**Report for Chorus**

UCLL and UBA FPP  
further draft  
determination  
submission – PUBLIC

*11 August 2015*

**Ref: 38598-292**

Figure 2.1:  
Understanding of modelling of assets related to the network from the road trench to the building, as shown for a building requiring a road crossing  
[Source: Analysys Mason, 2015]

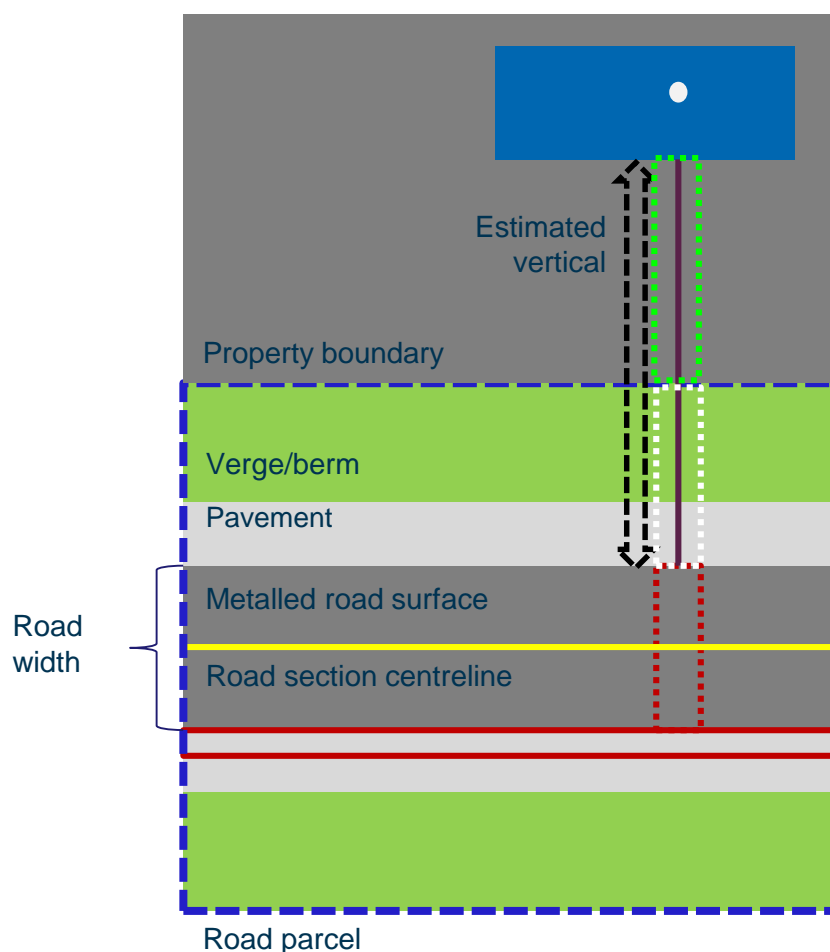
At the moment, therefore, lateral trenches are not included in the cost model. The purpose of laterals is to connect the road network trench to the property boundary.

In the TERA model, this would effectively be the part shown by the white dotted outline, shown in Figure 2.1 above.

Laterals are not part of the lead-in. They should therefore not be assumed to be included within the lead-in trench (and therefore should not be excluded from the model on the basis that lead-in assets are covered by the installation charge).

We recommend that the Commission revise the model in a consistent way. On the basis that the road trench runs beside the metalled surface of the road in the current model, we recommend the Commission calculate the length of trench required from the metalled surface of the road to the edge of the property boundary. This trench length should then be included for each building passed by the modelled network.

Figure 2.3: Illustration of trench sharing inputs for vertical trenches (all three points have the same PARENT\_TRENCH value, equal to 1,649,172) [Source: Commission geodata, 2015]

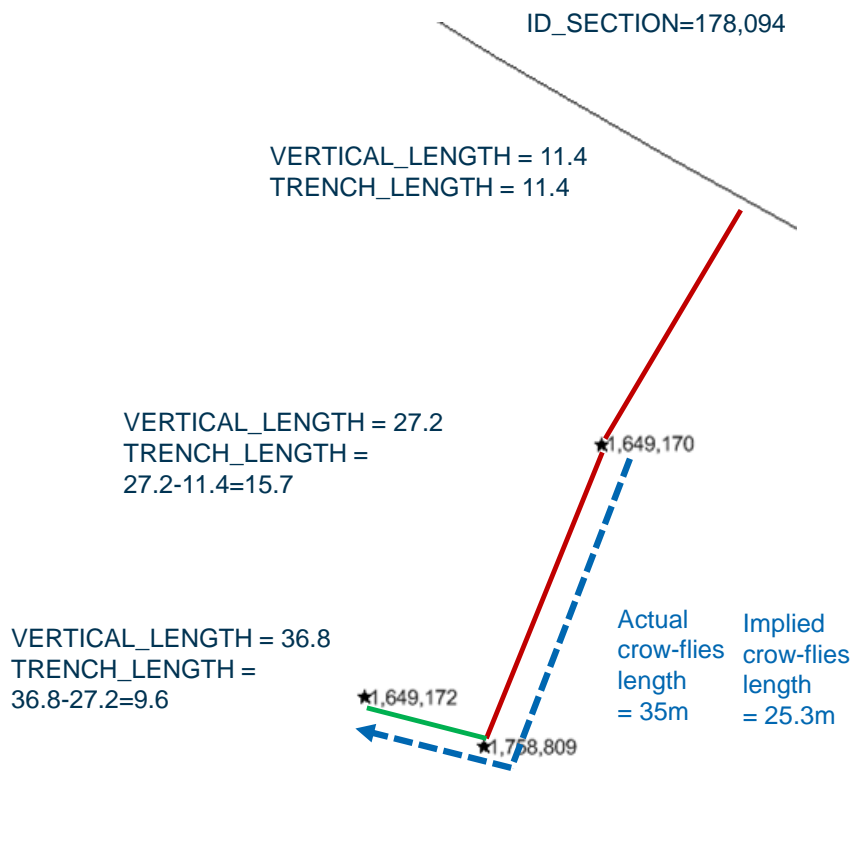
The SOURCE BUILDINGS table in the Access Database includes a new field called “TRENCH LENGTH”, a value which is pre-calculated (i.e. it is not calculated in the database as far as we can identify –which is a process transparency issue).

We have identified two issues with this implementation.

First, the trench required is being systematically under-estimated. The error is that the model calculated distance appears to be the difference between the (original) VERTICAL\_LENGTH values even if these two verticals are not collinear. This formula would only be correct in those cases where the buildings are all in a straight line perpendicular to the road section: however, this formula is being used for a wider set of premises when this is not the case. For example, in the example above, the amount of trench required to join the three buildings to each other via two indirect lead-ins (dotted blue line) is calculated as 25.3 m (15.7 m+9.6 m) in the current model, compared to approximately 35 m which would be required in reality (assuming a “daisy chain” of straight line links).

The TRENCH\_LENGTH values should be made more accurate, by using the co-ordinates of the points to derive an appropriate “daisy chain” based on crow-flies length.

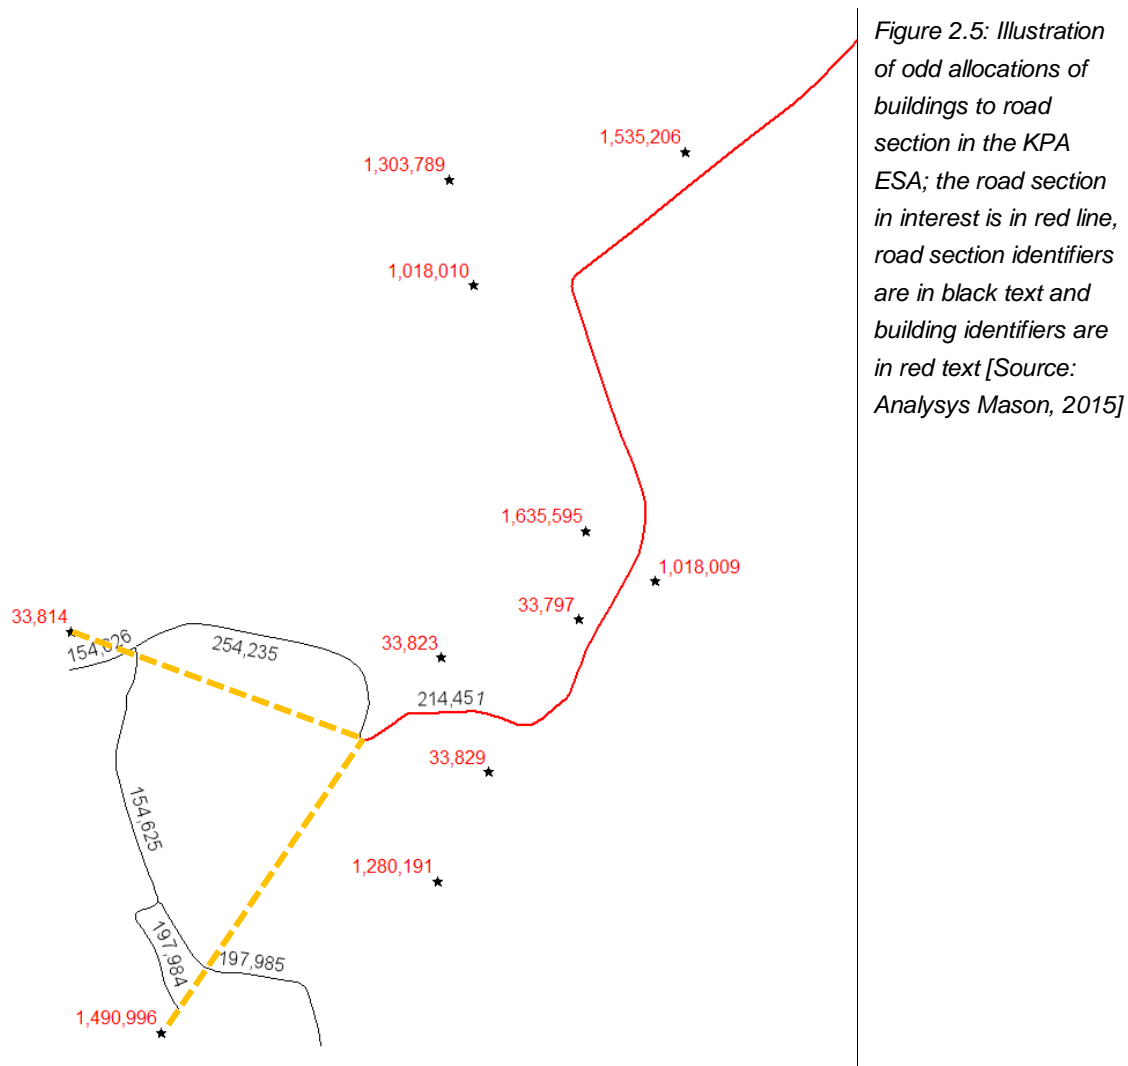
In Section 2.5 of the Analysys Mason submission February 2015, Analysys Mason noted that the mapping of buildings to road segments was incorrect.

The example we provided (shown below in Figure 2.5) illustrated a road section in Kaukapakapa (KPA) ESA and all of the buildings allocated to this road section. As shown below, there are 11 buildings allocated to the road section. However, two of these buildings were closer to other road sections shown in grey.

On page 5 of the TERA review of submissions, TERA stated that “this point has been assessed and no change is needed.” No rationale is given. We have investigated this issue further, since we believe that this issue is a material one, particularly since a significant amount of infrastructure related to the vertical length is now excluded from the modelled cost.

We can provide a shapefile of the line segments between each building and its nearest road section (including the mapping of ID\_SECTION and ID\_BUILDING) to enable the Commission to review this if this is useful.

Figure 3.2: Comparison of average trench costs implied in the two releases of the TERA model [Source: Analysys Mason, 2015]

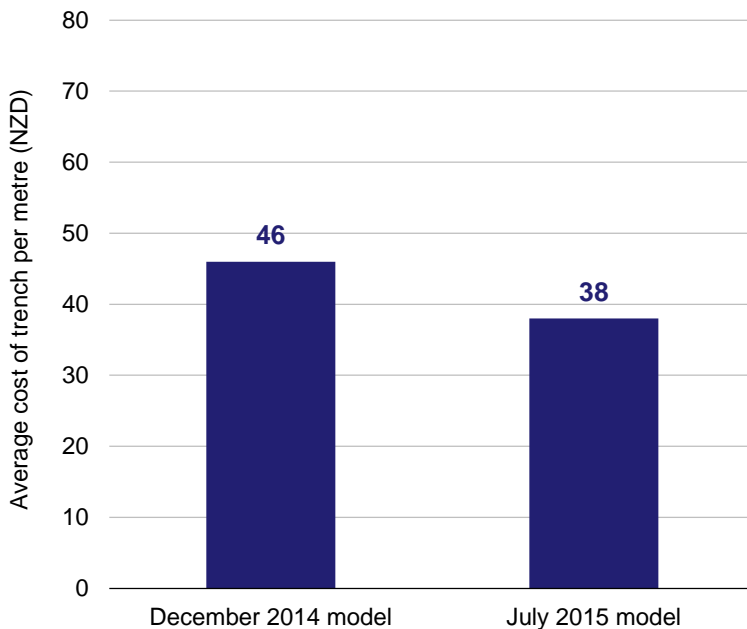
When we compare the average cost of trench in the December 2014 and July 2015 versions of the TERA model, we can see from Figure 3.2 that the net change of all the assumptions is a *reduction* in the average cost of trenching, when calculated according to the assumptions in Figure 3.1 above (i.e. a copper network passing all buildings, with 5% aerial, excluding vertical trenches, only including installation for the first duct, excluding all other duct/cable/manhole costs).

One reason for this reduction is the introduction of the mole ploughing trench method, which is assumed by TERA to be significantly cheaper than methods like chain digging and directional drilling.

Figure 3.5: Illustration of drill hole assumptions used by Beca for 110mm ducts (physically impossible assumptions shown in red) [Source: Analysys Mason, 2015]

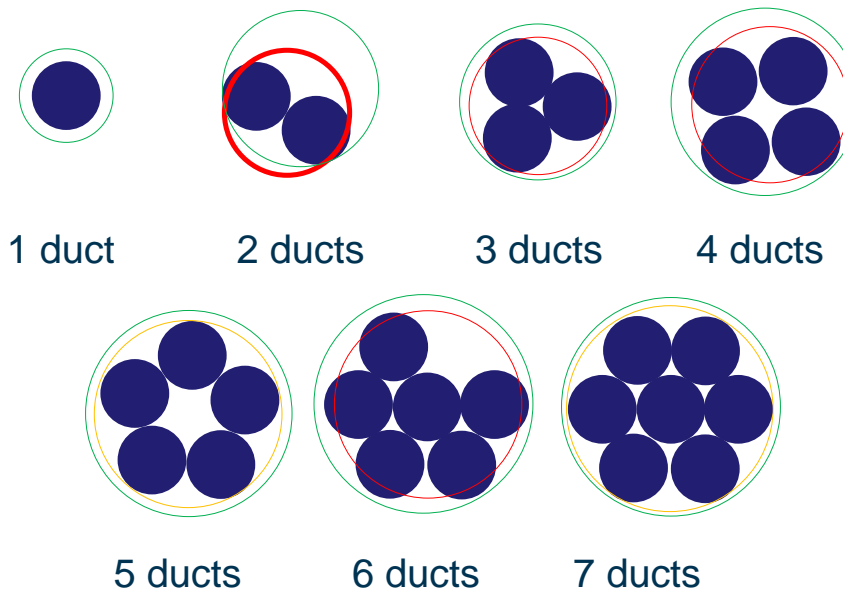
We illustrate the current Beca 110mm duct drill hole assumptions in Figure 3.5 below for the seven cases assumed in the calculation. Where the Beca assumption is not physically possible, we highlight these drill holes by red rings. Where they are possible, or where we have a more appropriate diameter, we highlight these with green rings. Where we think the assumption is physically possible, but not reasonable, we highlight these with yellow rings.

In particular, the assumption that two 110mm ducts can fit into a 150mm drill hole (shown by the thicker red ring below) is incorrect.

We therefore recommend that the changes summarised in Figure 3.6 below should be made. The assumptions for five ducts and seven ducts, although possible, lead to tightly packed drill holes. The five duct case, assuming they were arranged in the pentagonal configuration shown above, would fit tightly in a 0.297 metre drill hole, whilst the seven duct case fits exactly into the assumed 0.330 metre drill hole. We think it is reasonable to increase the diameter size for these cases as shown below, since otherwise there is a risk of duct damage upon installation into such tight fitting drill holes.

Ducts	Cell reference	Current value (metres)	Revised value (metres)
2	C37	0.20	0.25
3	C38	0.22	0.25
4	C39	0.25	0.30
5	C40	0.30	0.33
6	C41	0.30	0.35

Figure 4.1: Scope of UBA and associated services [Source: Commerce Commission, 2015]

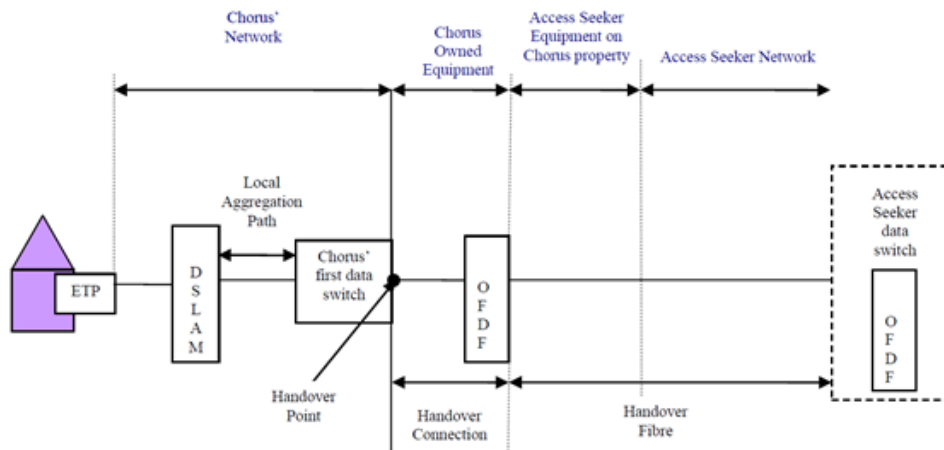
TERA include only a share of the switch costs in the handover connection, and omit the costs of the fibre cables from the FDS to the OFDF and the costs of the OFDF itself.

Figure 5.1: Eircom quarterly LFI since Q2 2008 [Source: ComReg regular reporting, 2015]

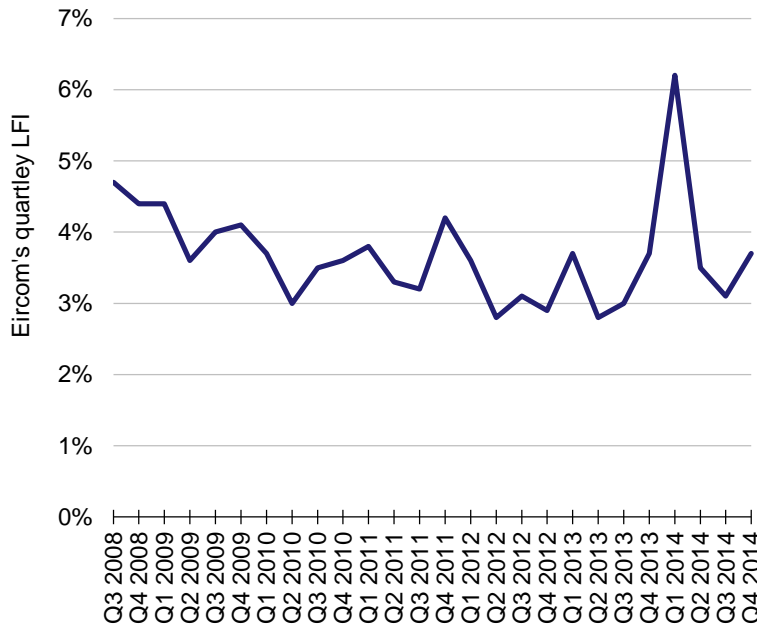
For the July 2015 release of the model, TERA has full-year data for Eircom’s fault rate for the period Q3 2013–Q2 2014. This included the highest quarterly fault rate for Eircom since the first reports were published in Q2 2008, as shown below in Figure 5.1 below.

Figure 5.2: Rolling average annual LFI for Eircom [Source: ComReg regular reporting, 2015]

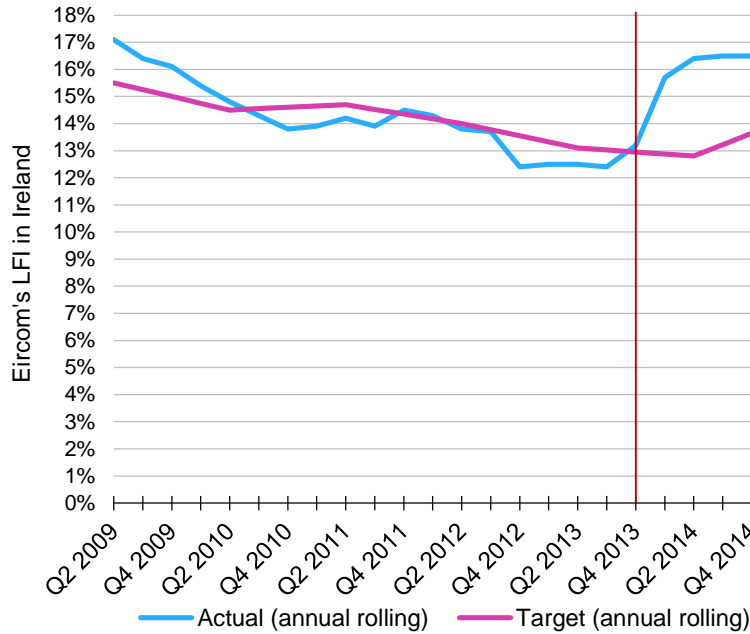
TERA has changed its calculation and used the actual fault rate for the period Q3 2013–Q2 2014 to drive the calculation of target LFI in New Zealand. This is despite this actual fault rate for Eircom being strongly affected by a single exceptional period and as a result the highest rolling average since early 2009, as shown by the light blue line in Figure 5.2 below.

This approach leads exceptional events that induce higher network maintenance costs for a limited period in Ireland to induce lower modelled network maintenance costs (and therefore wholesale prices) for a much longer period in New Zealand. The effects of such exceptional events ought to be disregarded in any case; second, it is unreasonable to view exceptional poor performance in Ireland as implying lower costs in New Zealand.

We suggest that the Commission should revert to using 12.8% as the relevant “actual” figure for Eircom.
